# HISTORIC AND DESIGN REVIEW COMMISSION

**HDRC CASE NO:** 2021-065  
**ADDRESS:** 1024 DAWSON ST  
**LEGAL DESCRIPTION:** NCB 1371 BLK 3 LOT E 38 FT OF 14  
**ZONING:** RM-4, H  
**CITY COUNCIL DIST.:** 2  
**DISTRICT:** Dignowity Hill Historic District  
**APPLICANT:** Mark Flinn/FLINN MARK  
**OWNER:** Mark Flinn/FLINN MARK  
**TYPE OF WORK:** New construction of a 2-story rear accessory structure  
**APPLICATION RECEIVED:** January 21, 2021  
**60-DAY REVIEW:** Not applicable due to City Council Emergency Orders  
**CASE MANAGER:** Edward Hall

The applicant is requesting conceptual approval to construct a 2-story, rear accessory structure on the lot at 1024 Dawson, located within the Dignowity Hill Historic District.

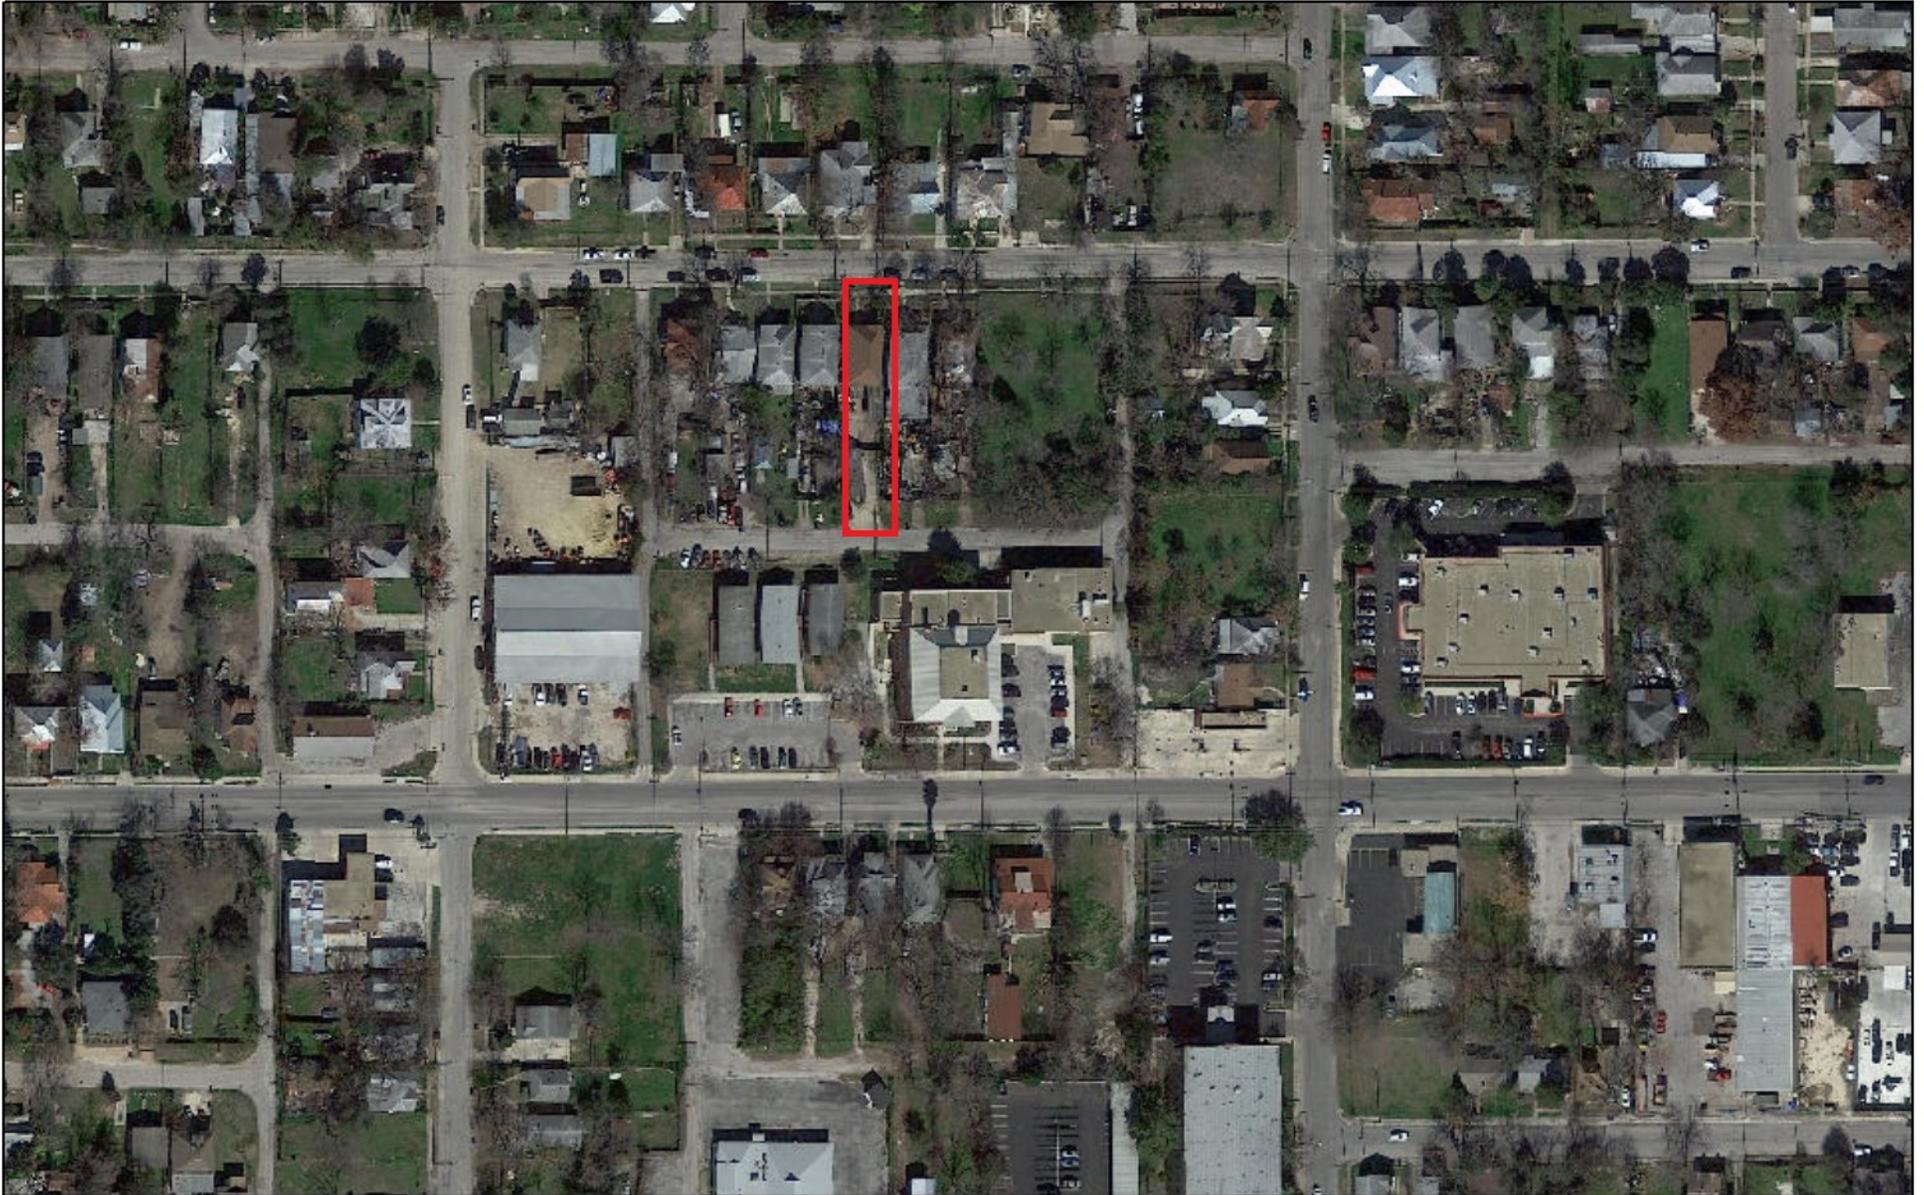
- g. **CHARACTER (Fenestration)** – The Guidelines for New Construction 5.A. notes that new accessory structures should relate to the primary historic structure in regards to their materials and window and door openings. The applicant has noted that the north and south elevations have been mislabeled, and that the proposed blank elevation will face the interior of the lot, and not the alley. Staff finds that the proposed accessory structure currently features window openings and fenestration patterns that are atypical of those found on the primary

historic structure, and are inconsistent with the Guidelines. Staff finds that all windows should feature sash profiles, and that fenestration should be added to the elevations labeled south and east, which are currently either void of fenestration, or feature large, unseparated wall planes. Additionally, staff finds that windows on the proposed accessory structure should feature profiles and sill details that are consistent with those of the primary historic structure on the lot.

- i. That the applicant perform studies to determine whether or not the structure's height can be further reduced, potentially through a reduction in roof form and roof height.
- ii. That all windows feature sash profiles, and that fenestration should be added to both the south and east elevations, which are currently either void of fenestration, or feature large, unseparated wall planes. Additionally, staff recommends that windows on the proposed accessory structure should feature profiles and sill details that are consistent with those of the primary historic structure on the lot.
- iii. That in developing construction documents for final approval, the applicant match the materials of the primary historic structure.

**VIEW FROM DAWSON STREET**

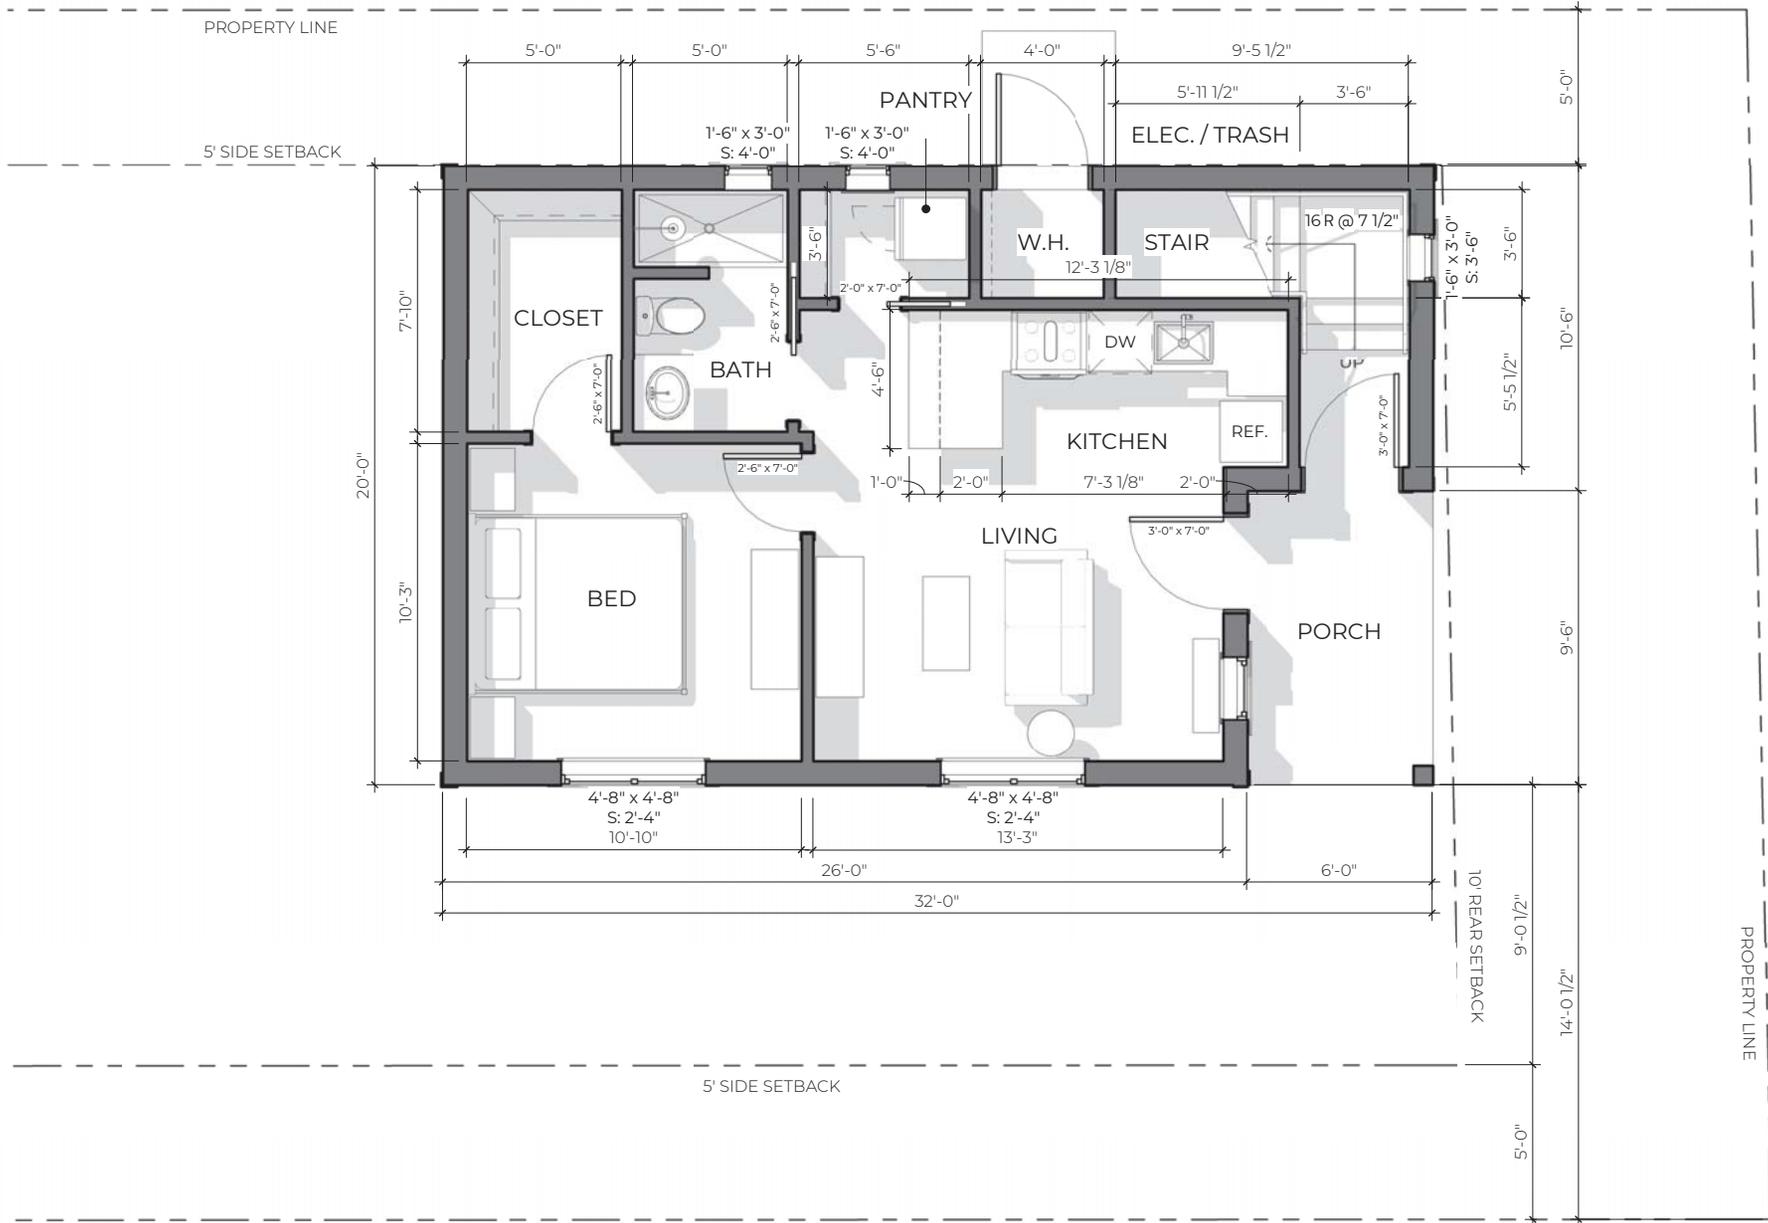
- d. **MASSING & FORM** – Regarding overall height, the applicant has proposed for the structure to feature an approximate height of thirty (30) feet. The applicant has submitted a line of sight study that notes that the proposed two story structure would not be visible from the right of way due to its distance from the right of way at Dawson. Staff finds that the applicant should perform studies to determine whether or not the structure's height can be further reduced, potentially through a reduction in roof form and roof height.
